APPLICATION NO.	FILING DATE	FIRST NAMED INVENTOR	ATTORNEY DOCKET NO.	CONFIRMATION NO.
09/635,902	08/11/2000	Kozo Harada	50090-234	8376

Office Action Summary

DETAILED ACTION

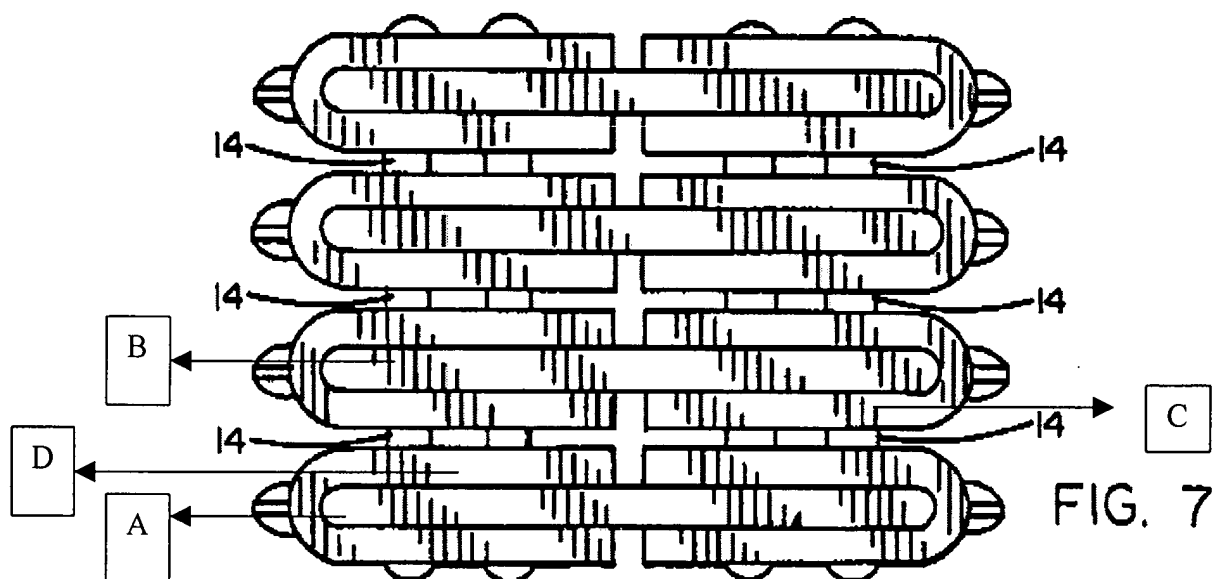
On page 10, applicant argues “Eide is completely silent as to what is formed on the TSOP chips 8 ... the TSOP chips 8 do NOT necessarily have **both** electrodes **and** conducting patterns under the conductive elements 5, 10 in the manner recited in claim 6.” This argument is not persuasive. Eide discloses in column 4, lines 31 ~ 40 the TSOP chips 8 having I/O terminals thereon and a flexible circuit.

Finally, applicant argues “Eide is ... completely silent as to the relative arrangement of electrodes and/or conductive patterns on the chips themselves ... the conductive patterns extending from the electrodes, let alone patterns which face each other on opposing chips and which are connected via a bump in the manner recited in claim 6.” This argument is not persuasive. Eide discloses in Figs. 3 ~ 7 the conductive patterns (7 in Fig. 3, under 5 in Fig. 7) extending from the electrodes (under 10), let alone patterns (C and D) which face each other on opposing chips (A and B) and which are connected via a bump (5).
